### **PROPOSED NEW BRICK FACTORY (SSD 10422)**

**416 & 524 BERRIMA ROAD, MOSS  
VALE, NSW 2577**

### **REVISED AIR QUALITY IMPACT ASSESSMENT**

**RESPONSE TO AGENCY SUBMISSIONS**

**Figure 3: Site Drawings Illustrating Enclosed Crushing Operations**

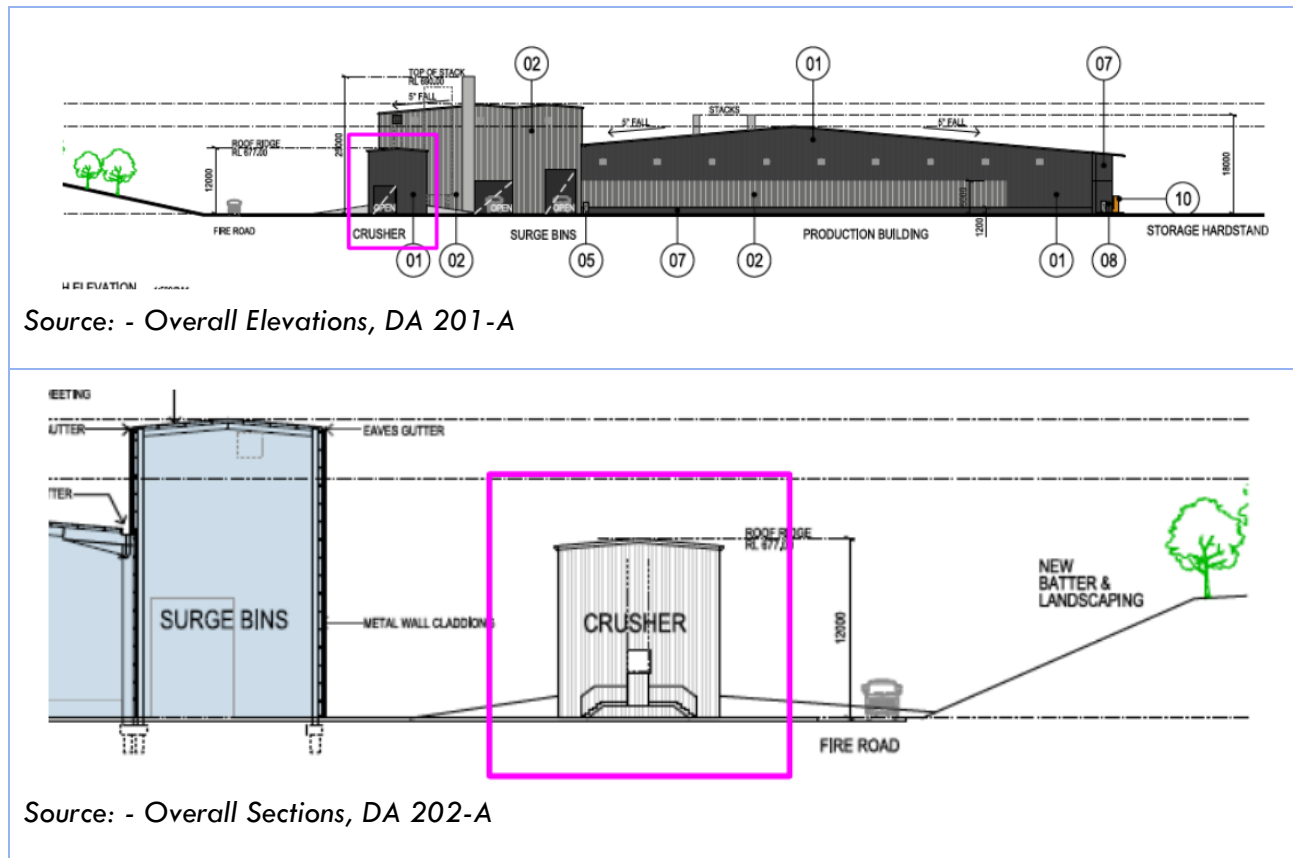
- The AQIA should confirm if the crusher will be enclosed as outlined in the draft concept plans.
- Any backup power supply systems should be documented including information on whether they will be diesel or gas fired engines. Such activities must be undertaken in accordance with the EPA's *Interim Nitrogen Oxide Policy for Cogeneration in Sydney and the Illawarra*.

- **Enclosed Operations to minimise Fugitive Dust:** Based on advice from Austral Bricks, it is noted that raw materials delivered to the site from the adjacent Austral Bricks Quarry would be conveyed and unloaded inside the raw material storage building, thereby considerably minimising wind erosion emissions from the stockpiles. Similarly, as shown in **Figure 3** below, the crusher infrastructure would be enclosed in a building, which significantly minimises the potential for airborne dust emissions resulting from the crushing and associated operations.

**Figure 4:** Land Use Zones Surrounding the Proposed Facility

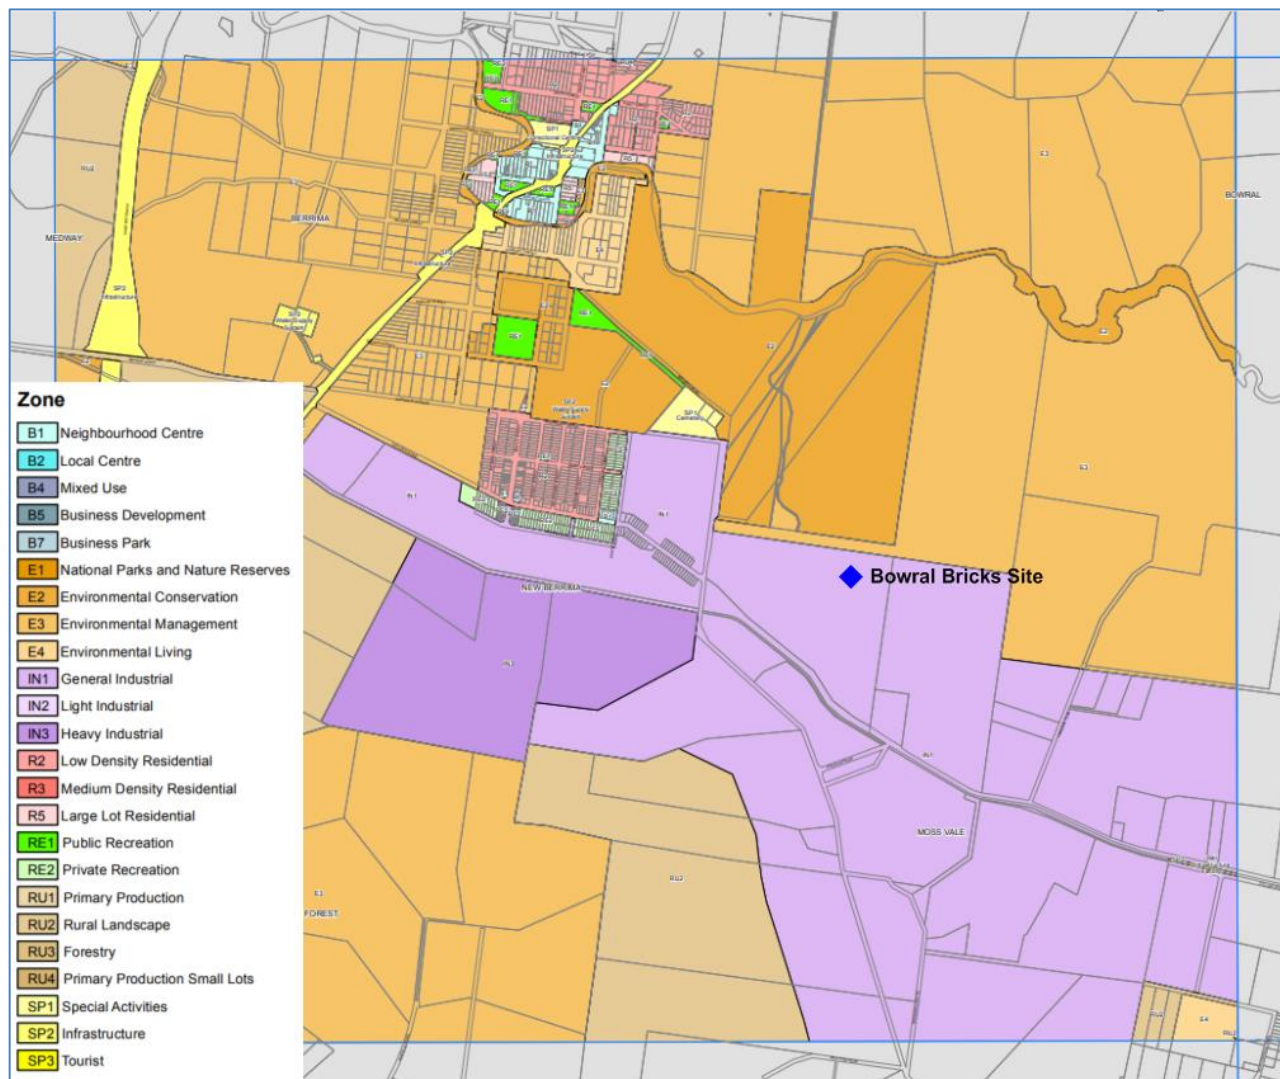
EPA in their comments expressed concerns whether the proposed facility's HF emissions would have an adverse impact on the nearby Environmental Conservation (E2) and Environmental Management (E3) zones as shown in **Figure 4**. To address EPA's concerns, model predicted incremental and cumulative HF ground level concentrations have been overlaid on the land zoning plan shown in **Figure 4**. Findings suggest that the general land use assessment criteria contour for the 24-hour averaging period (which is the most critical amongst all the HF averaging periods), does not encroach onto either the E2 or E3 zones. When the sensitive land use assessment criteria is applied for the 24-hour average concentrations, the assessment criteria contour extends into the E3 zone, but only limited to a very small area. Additional details regarding these findings are presented in **Section 11**.
